Project Addendum 1
(8 pages)

Project: FY24 Concrete Project

Date: January 26, 2024

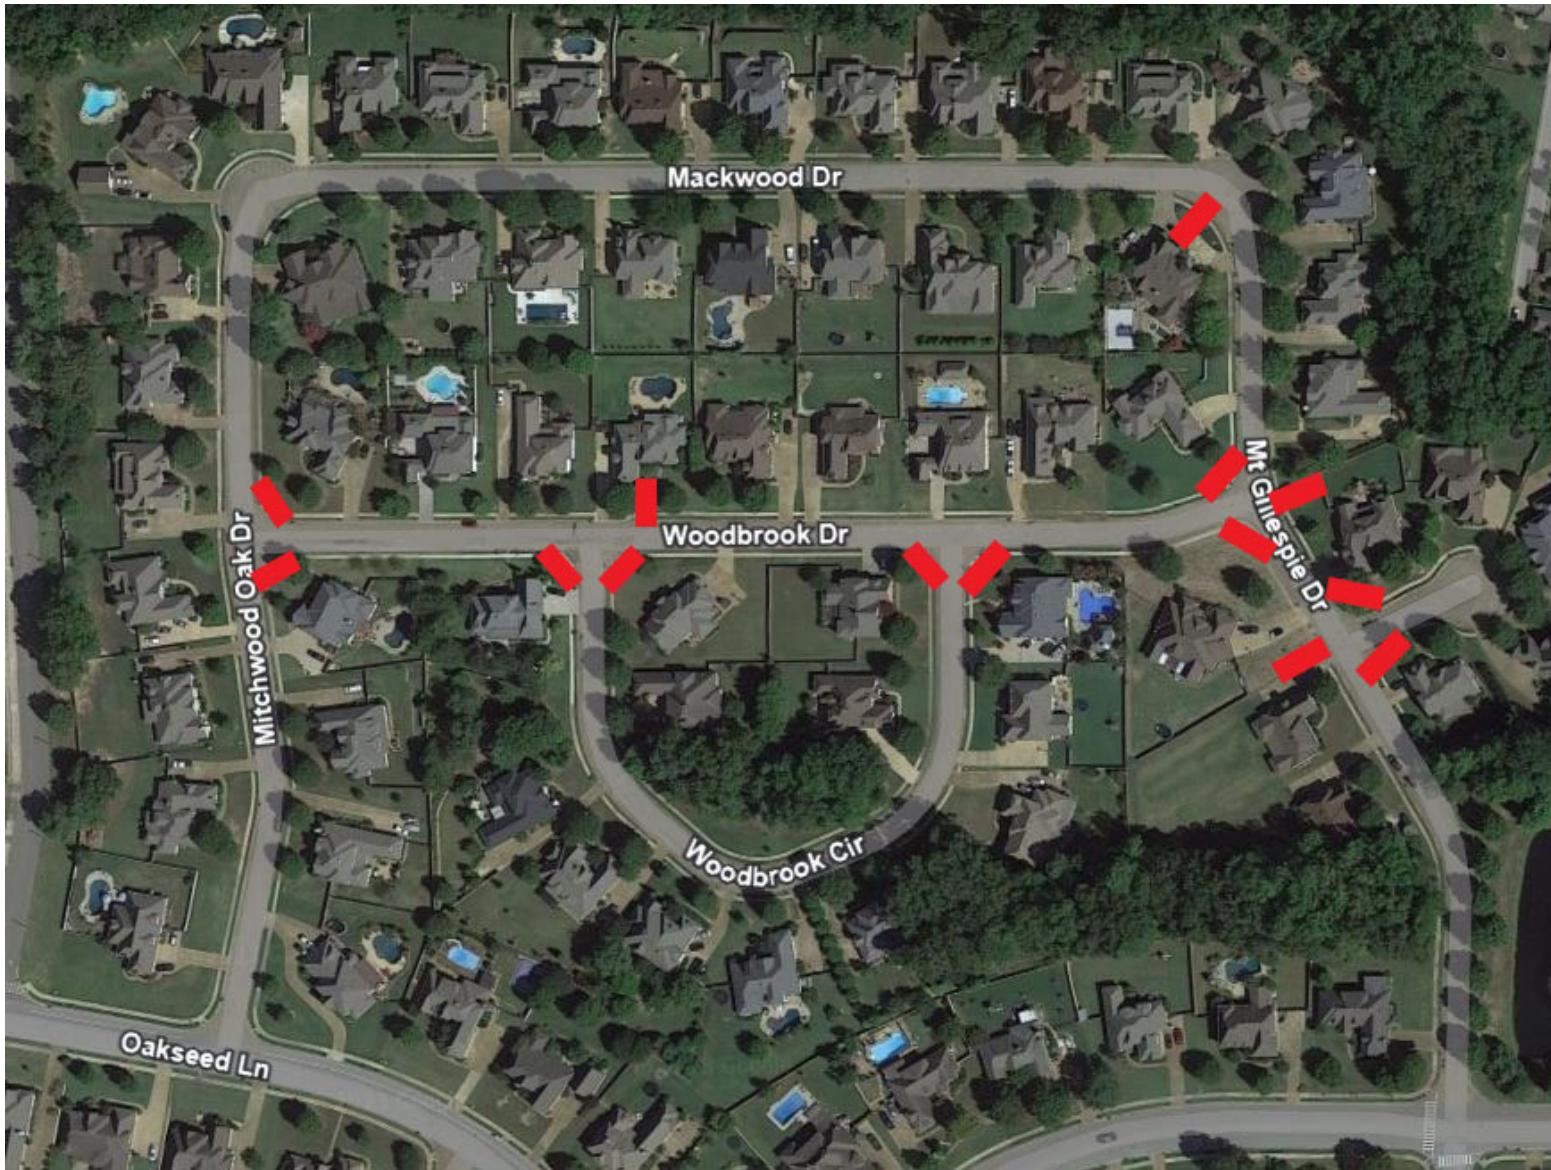
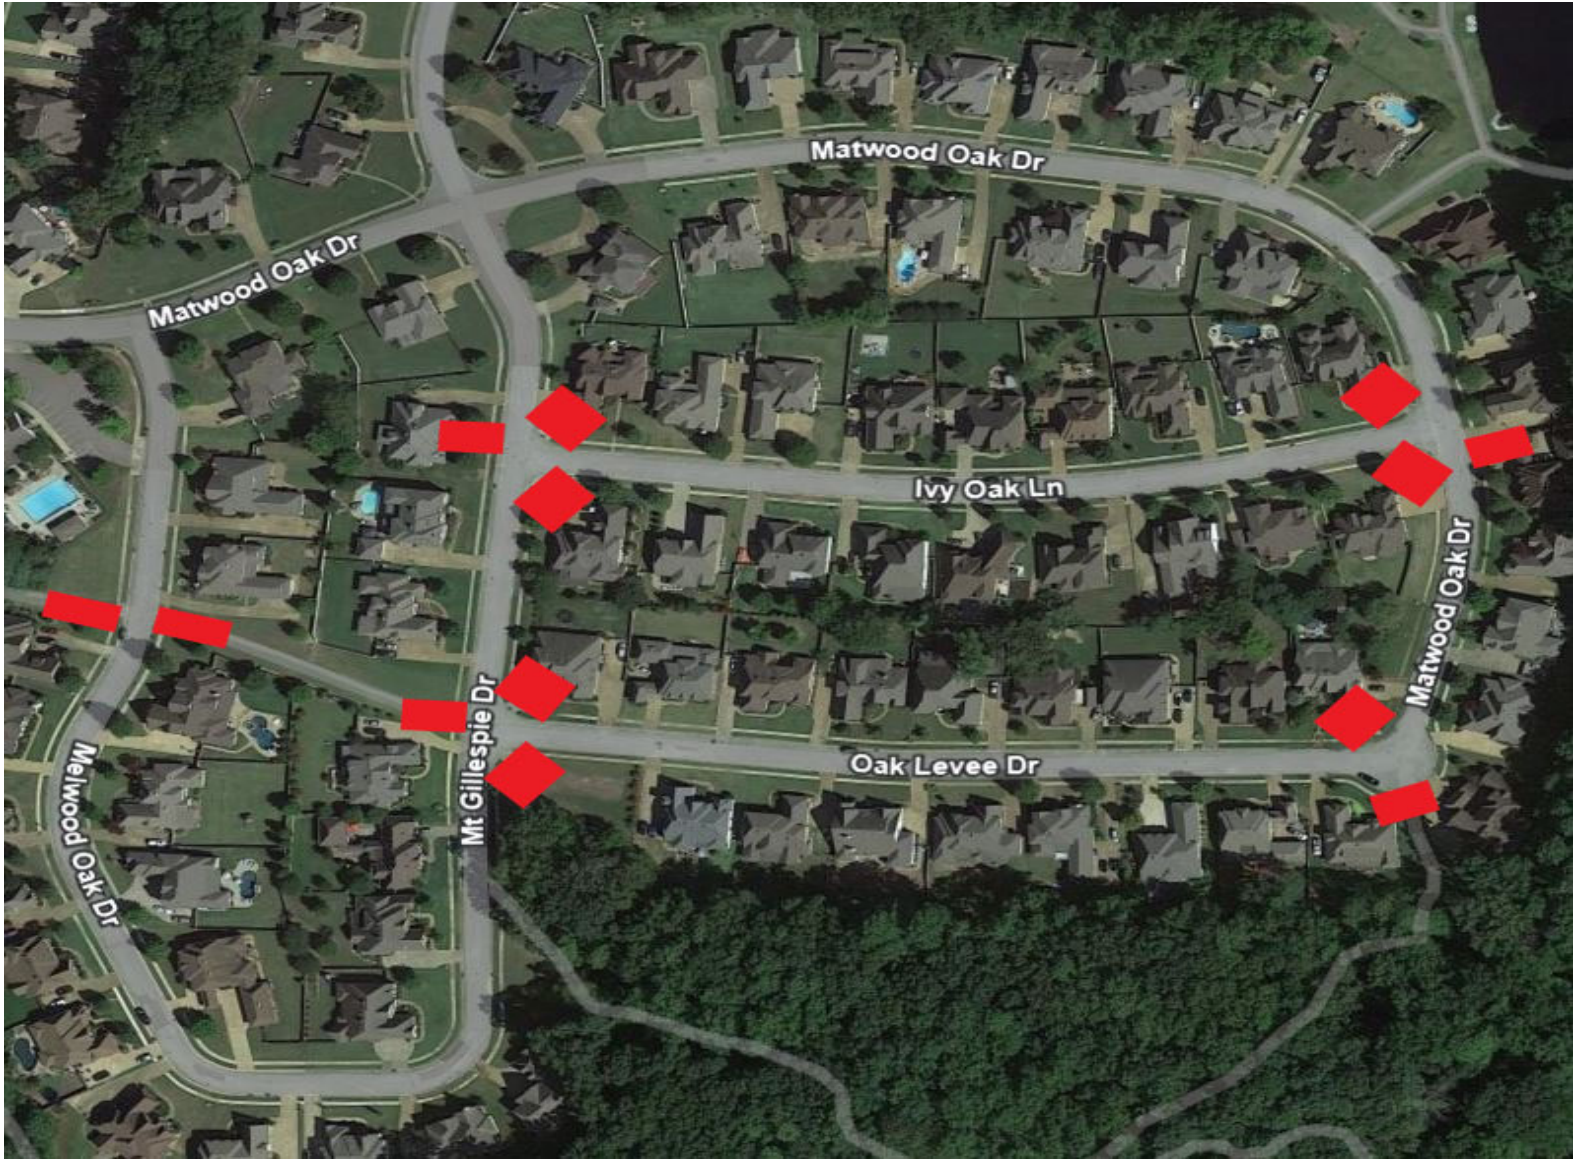
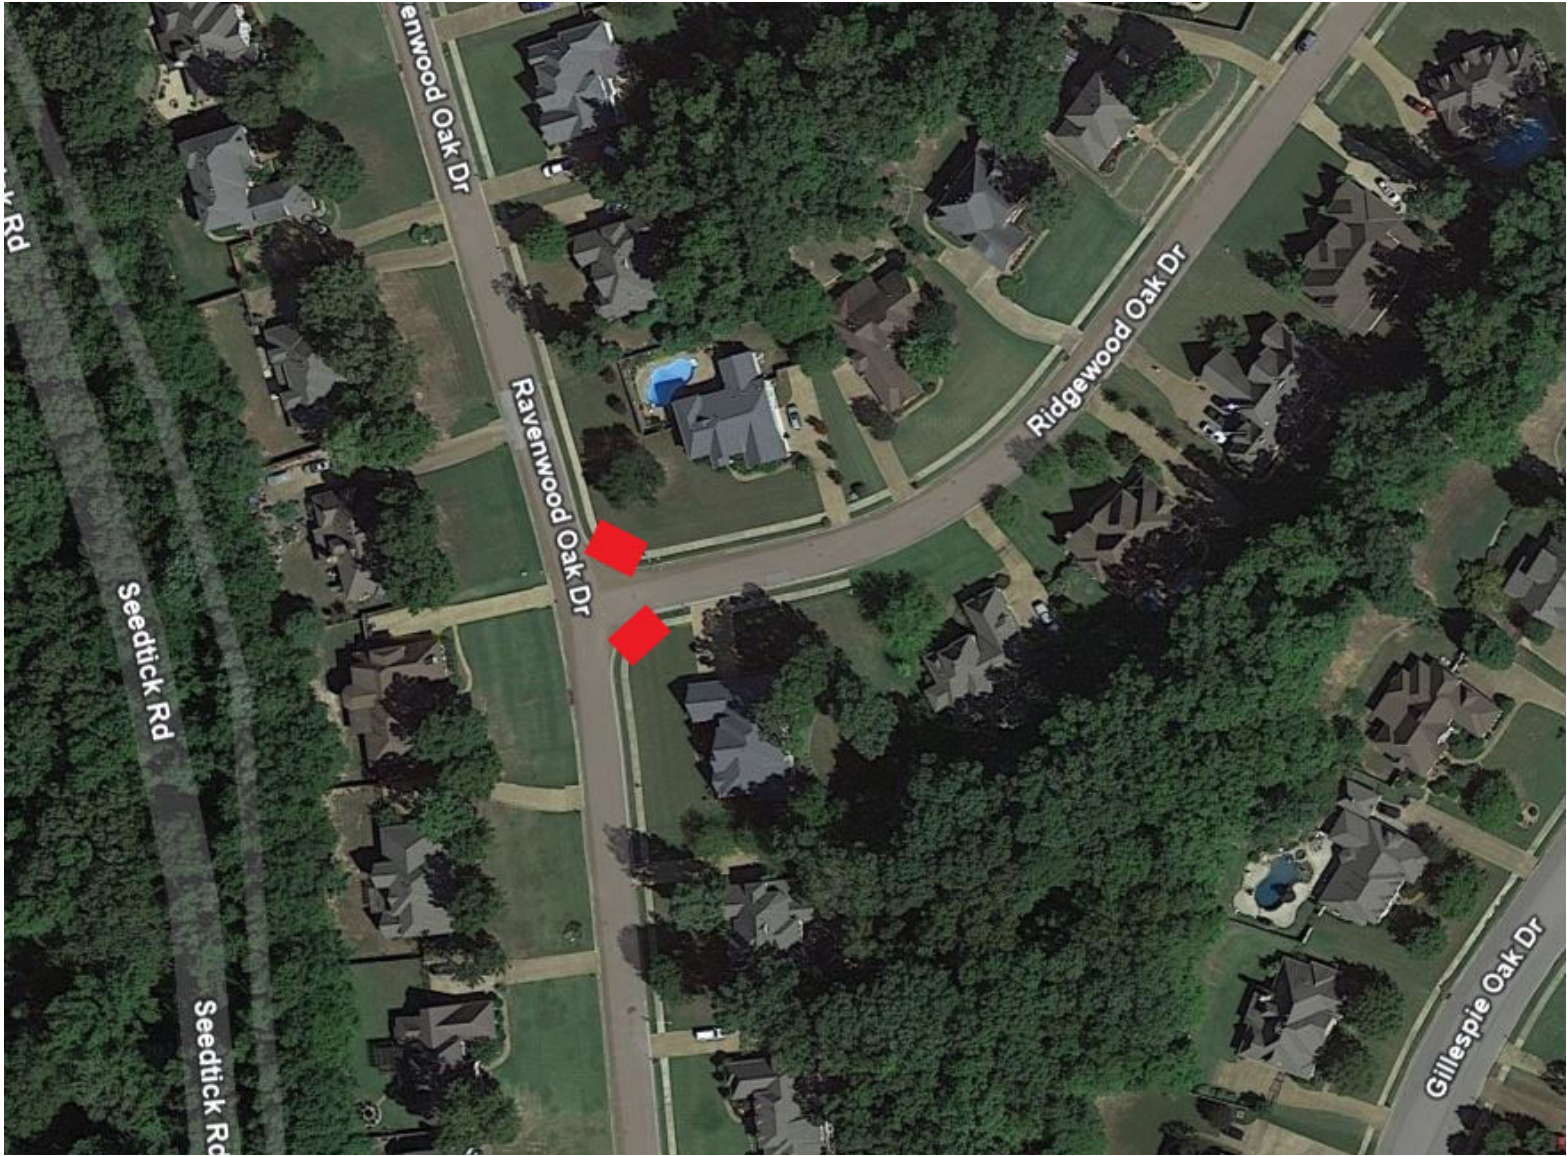
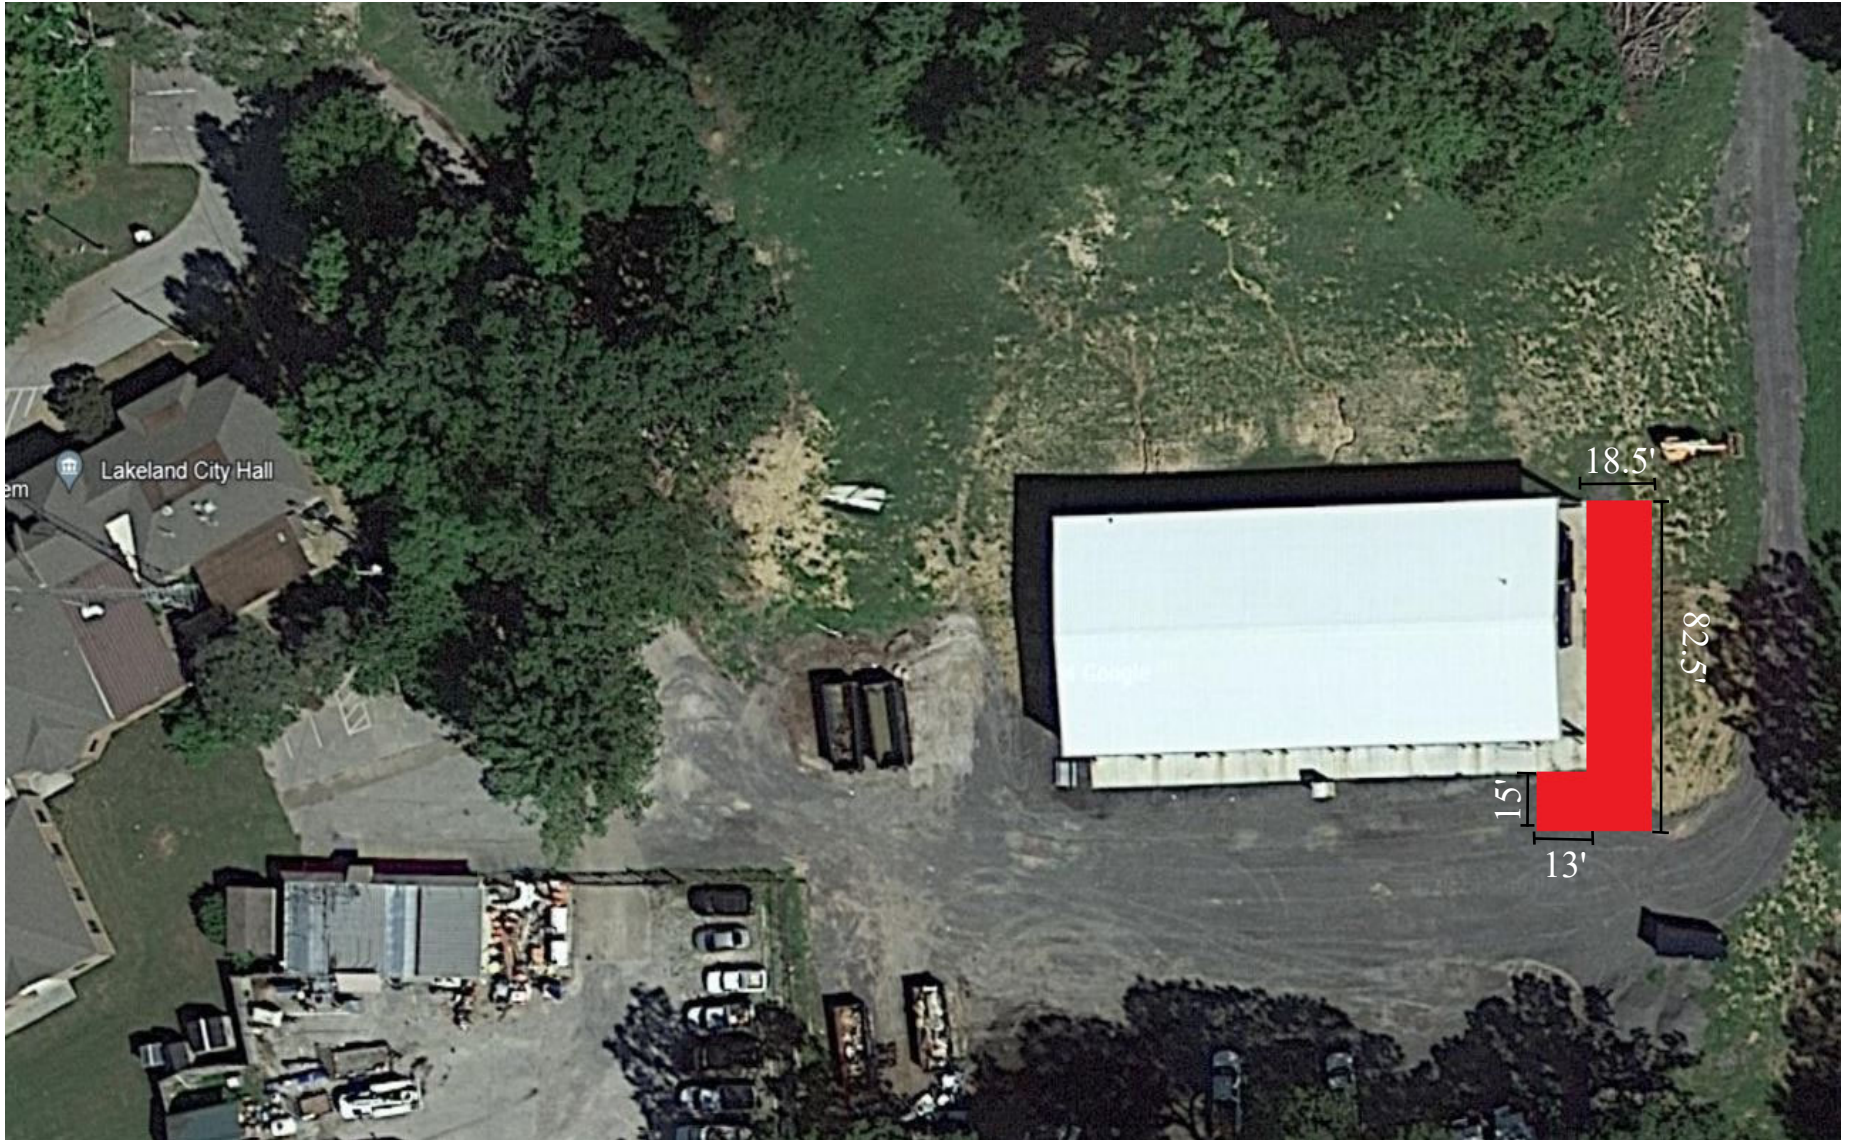
1. Appendix A, Addition of maps showing locations of where work will be performed.
2. Section 01650 Measurement and Payment Procedures, Part 2 Execution, 2.04 Item A, Add "asphalt"

The maps depict the location of ADA Ramps. They DO NOT depict the location of curb and gutter replacement.
